# Six Chuter Inc.

## SAFETY DIRECTIVE

### SD 2015-01 P3Lite

**1.4) Subject**  
Loose bolt connecting engine spar to the pylon spar.

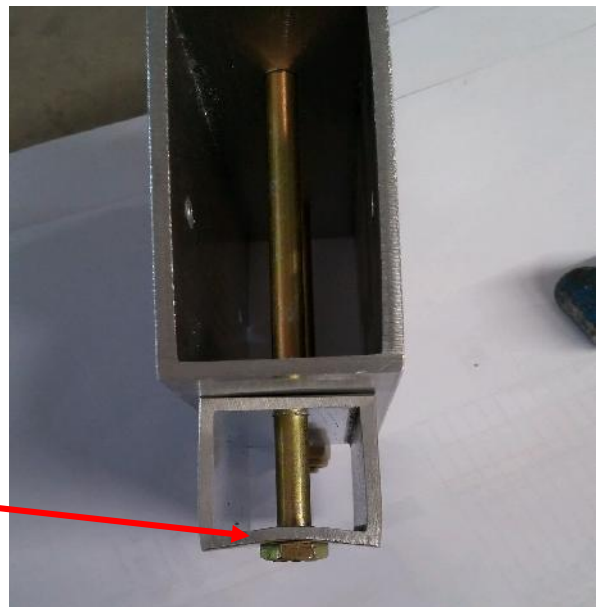
Two customer feedback forms have been received indicating a loosening of the bolt that connects the engine spar to the pylon spar. Analysis shows that this results from a deformation of the inner tube used to secure the engine tube to the spar. See photo at the right. This deformation could occur through over tightening of the nut on the front of the pylon spar, during construction, or through rough landings. As this bolt loosens, the engine spar can move causing undesirable vibrations.

**1.5) Compliance**  
Because this is an ultralight model there is no mandatory maintenance requirements. HOWEVER, Six Chuter International recommends installation of a new part, a pylon-engine plate that will significantly strengthen this installation. This part is now part of the kit parts on all models after serial number 3166. The factory will provide the necessary parts at no cost to all existing P3 Lite owners.
